MILLSTONE NUCLEAR POWER STATION UNIT NO. 1

Amendment No. 33
License No. DPR-21

MILLSTONE NUCLEAR POWER STATION UNIT NO. 2

Amendment No. 19
License No. DPR-65

FIGURE 6.2-1

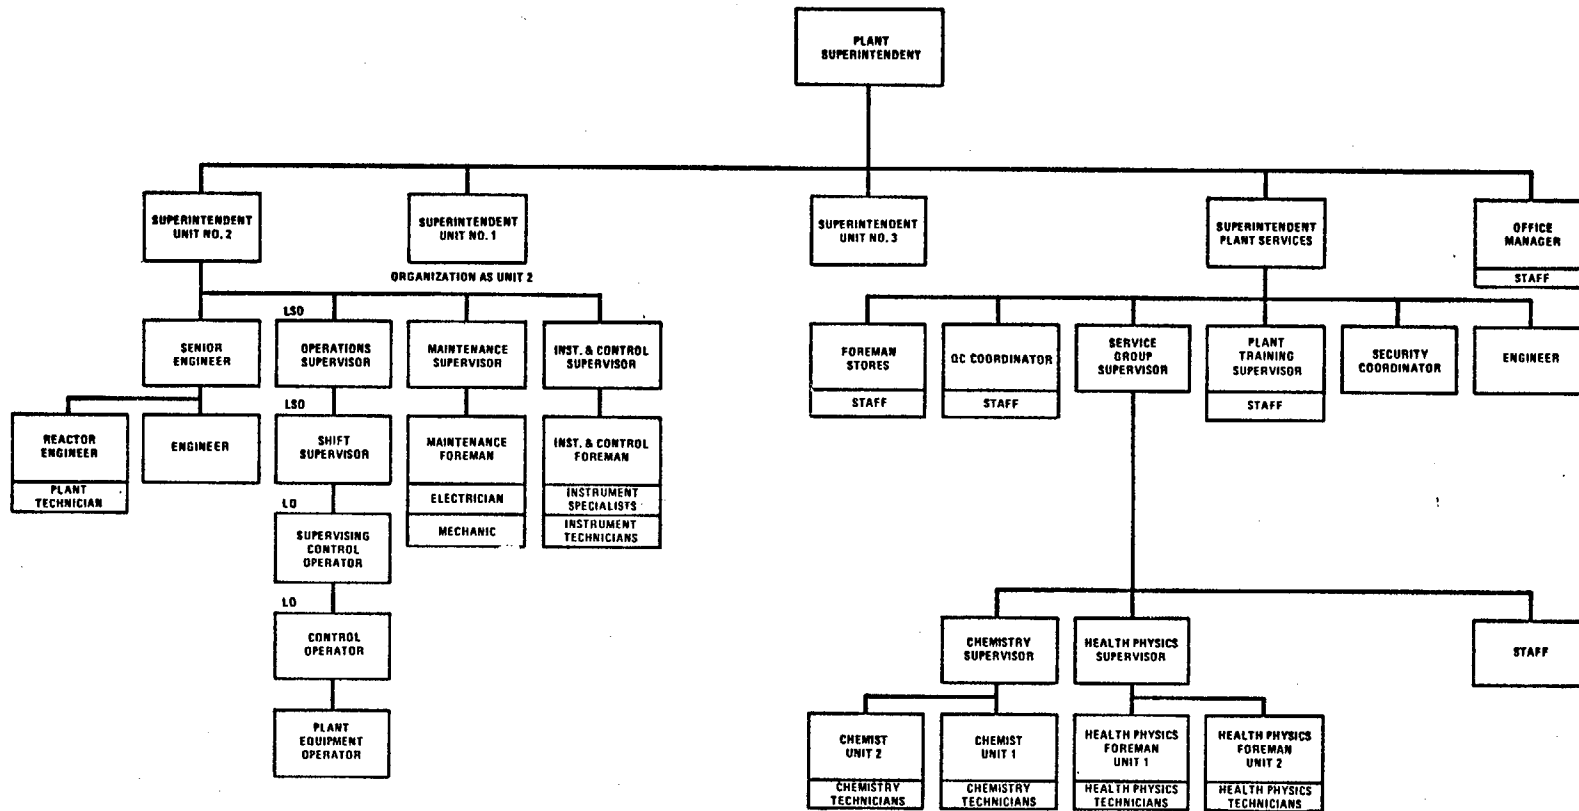
NNECO has proposed two changes to the offsite organizational structure contained in Millstone Units Nos. 1 and 2 Technical Specification 6.2.1. The first change involves the title "V. P. System Operations" which is being changed to "V. P. System Production." The second change involves a modification to the reporting level for the Nuclear Review Board (NRB) which reported directly to the President of NNECO. The proposed reporting level for the NRB is the Vice President of NNECO who in turn reports to the President of NNECO.

The proposed modifications to the offsite organization are acceptable since they in no way degrade the managerial, technical support, or review and audit functions of the offsite organization.

FIGURE 6.2-2
 Facility Organization – Millstone Nuclear Power Station - Unit 2

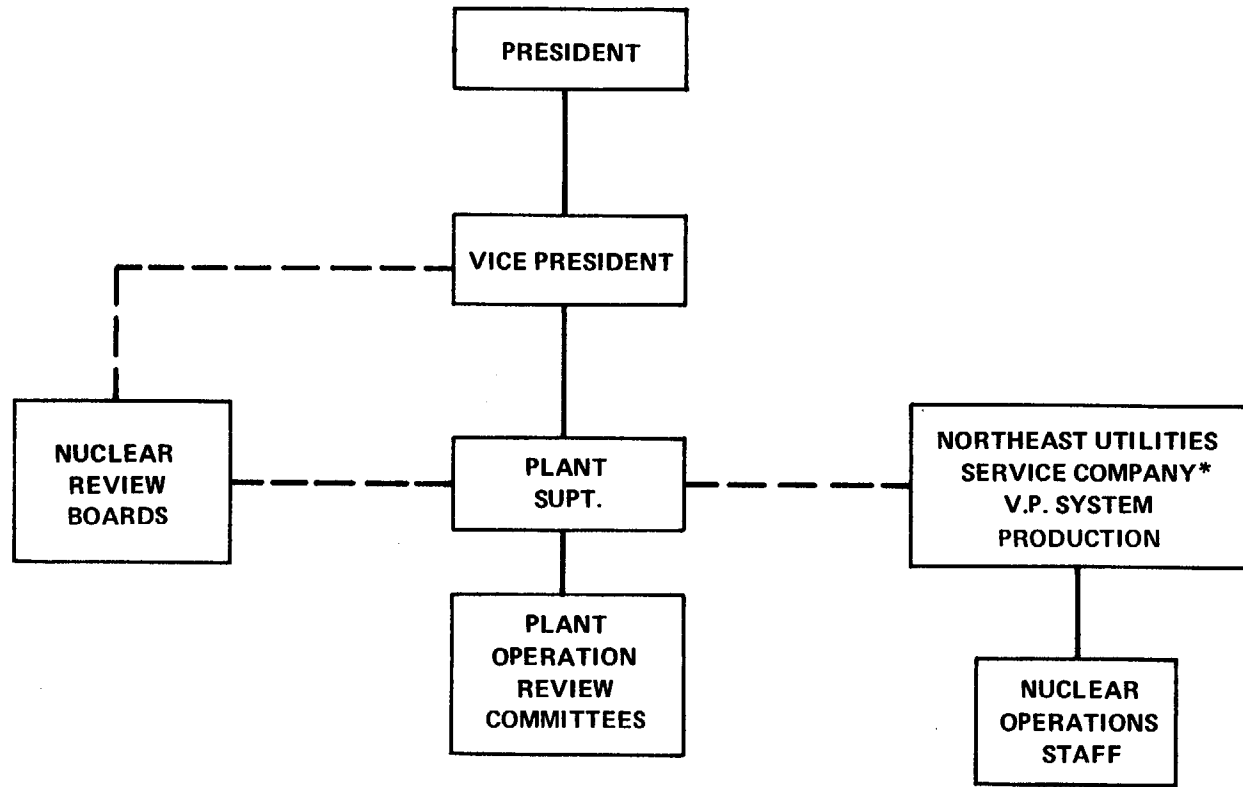
NNECO has proposed a number of changes to the onsite organization for Millstone Units Nos. 1 and 2 as stated in Technical Specification 6.2.2. The only significant change is that the Quality Control (QC) Coordinator, who formerly reported directly to the Plant Superintendent, now reports through the Superintendent of Plant Services to the Plant Superintendent.
